# Staff Summary Report

**SUBJECT:** Hold a public meeting for a Development Overlay for FOUNTAINHEAD OFFICE PLAZA, located at 1625 W Fountainhead Parkway.

**DPR08237** – Development Plan Review including site plan, building elevations and landscape plan.

ELEVATIONS  
 6 STORY

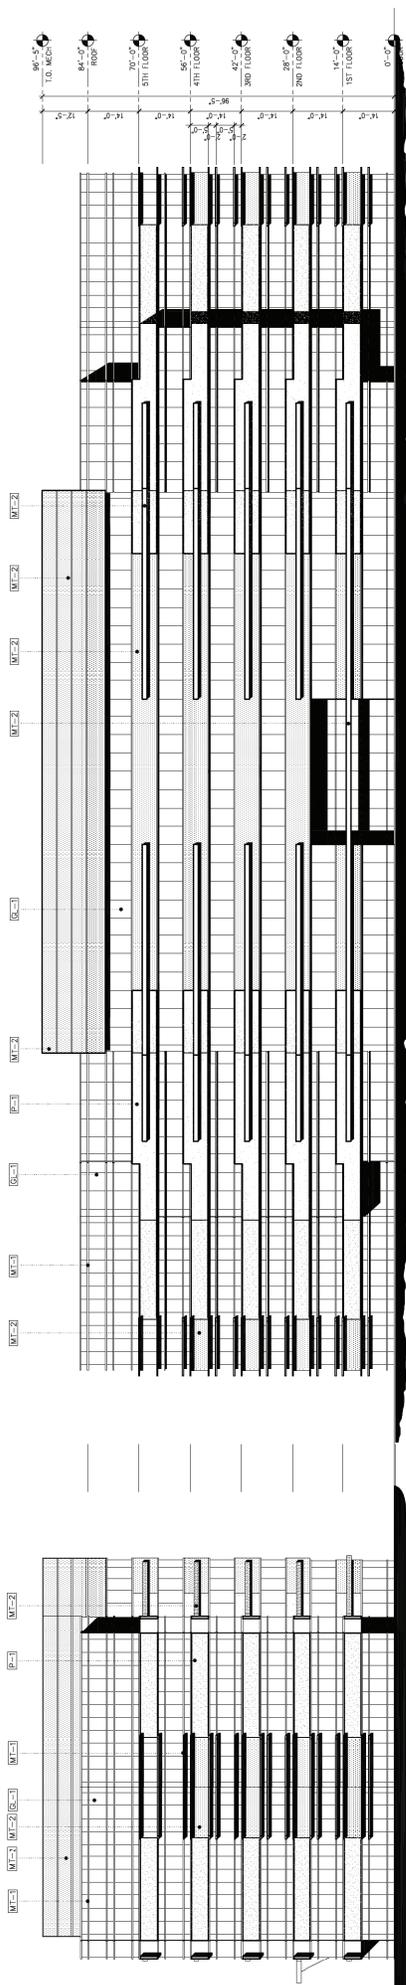
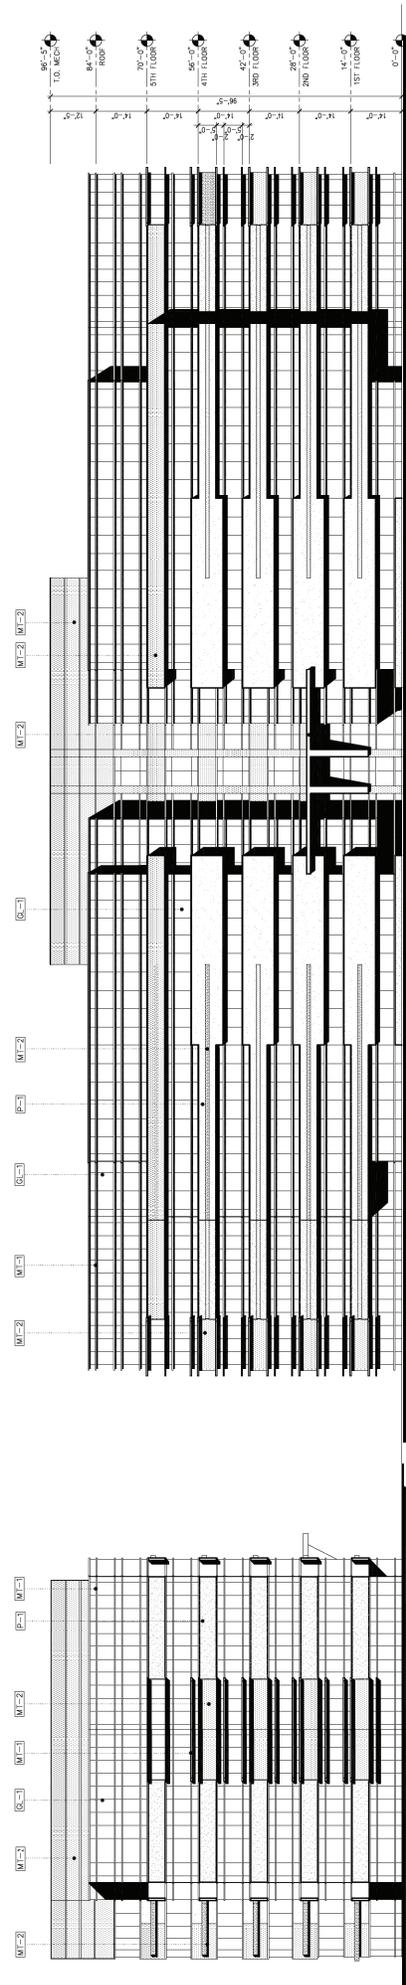
13. The materials and colors are approved as presented:  
Integral Colored Concrete – to match Dunn Edwards paint color DE6242 Wells Grey LRV 43  
Metal panel painted to match ATAS 70 Clear  
Clear anodized aluminum frame – to match Arcadia #11/Clear AC-2  
1" Insulated glass to match Versalux Blue 2000T Subdued Silver Reflectance  
Provide main colors and materials with a light reflectance value of 75 percent or less. Specific colors and materials exhibited on the materials sample board are approved by planning staff. Submit any additions or modifications for review during building plan check process.

14. Provide secure roof access from the interior of the building. Do not expose roof access to public view.
15. Conceal roof drainage system within the interior of the building.

16. Incorporate lighting, address signs, and incidental equipment attachments (alarm klaxons, security cameras, etc.) where exposed into the design of the building elevations. Exposed conduit, piping, or related materials is not permitted.

ELEVATIONS  
 GARAGE

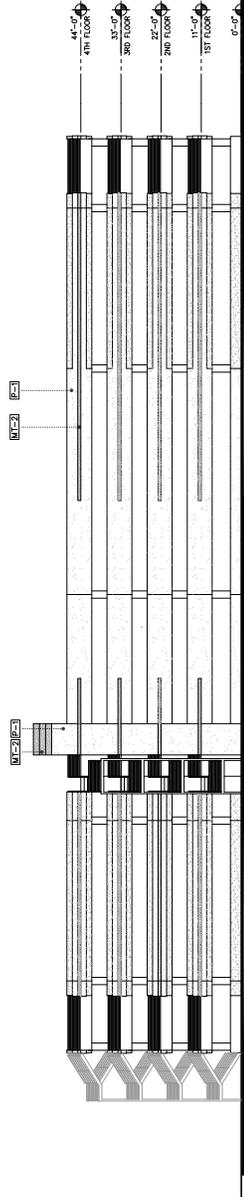
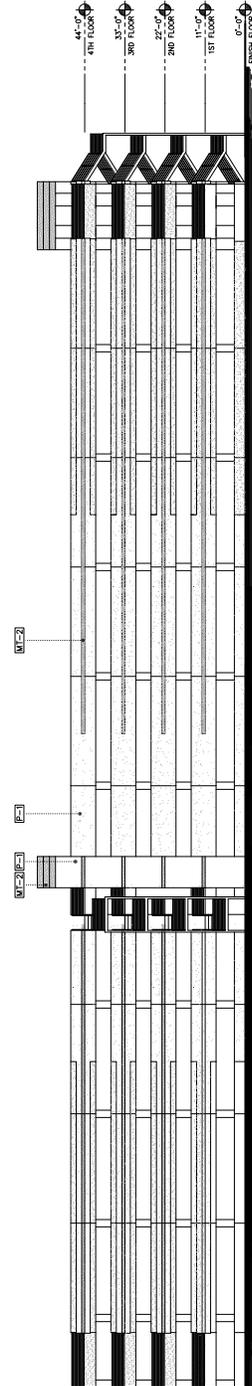
11. Garage Security:
  - a. Minimize interior partitions or convert them to semi-opaque screens to inhibit hiding behind these features.
  - b. Provide exit stairs that are open to the exterior as indicated.

- c. Paint interior overhead surfaces in garage floor levels with a highly reflective white color, minimum LRV of 75 percent. For levels below grade, paint walls and overhead surfaces.

- d. Maximize openness at the elevator entrances and stair landings to facilitate visual surveillance from these pedestrian circulation areas to the adjacent parking level.

12. Parking Garage:
  - a. Minimum required parking dimensions shall be clear of any obstructions.
  - b. At the ends of dead-end drive aisles, provide a designated turn-around space, minimum 8'-6" clear in width (locate on left side if available), including 3'-0" vehicular maneuvering area for exiting. Turn-around area shall be clearly demarcated.
  - c. Provide a minimum 2'-0" of additional width for parking spaces when adjacent to a continuous wall.
